PRELIMINARY OVERALL AREA DEVELOPMENT PLAN PECAN VALLEY ESTATES

INFORMATION SHEET FOR
PRELIMINARY OVERALL AREA DEVELOPMENT PLAN
(P.O.A.D.P.)

Re: Pecan Valley Estates P.O.A.D.P. revision

Re: Pecan Valley Estates Preliminary Plan
 P.O.A.D.P.
File #: 84-18-56-62

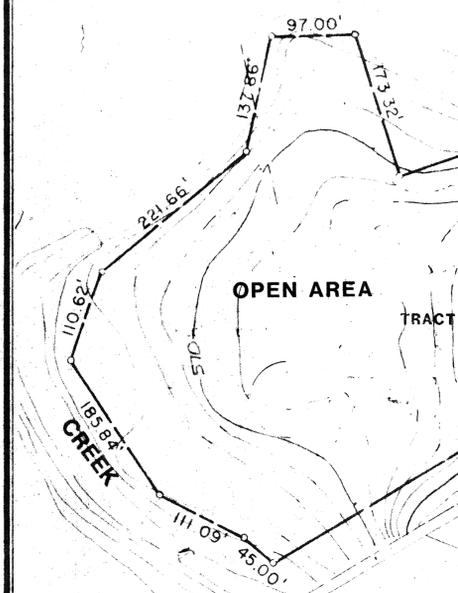
**REVISED POADP
CLARIFYS PUBLIC &
PRIVATE STREETS
AS REQUESTED
33.473 Acres
By COMMITTEE ON
2-B-S.S. PLAN ALSO
REFLECTS CUL DE SAC.
AN OPEN SPACE COMMON**

Committee reviewed 12-14-84 It was recommended that Spring Ave be designated as a public street in entirety, or that it end de sac be provided where the public st. terminates.

It is recommended that the proposed street linking Roland Avenue and Springview Drive be designated as a public street or provide a cul-de-sac turnaround were your planned public street terminates.

Comments: *It is recommended that the ^{proposed} street linking Roland Ave. & Springview Dr. be designated as a public street in its entirety. Staff believes it is essential, in this instance, to have direct access into the property from Springview Dr. or Roland Ave. at all times.*

- () See annotations/comments on attached copy of your plan.
- (x) Comments: This acknowledges receipt of the revised POADP reflecting the cul-de-sac turn around as per staff comments dated 12-18-84. With regard to this no objection is offered.

Comments: This acknowledges receipt of the revised POADP reflecting the cul de sac turn around as per staff comments dated 12-18-84. with regard to this no obj is offered.
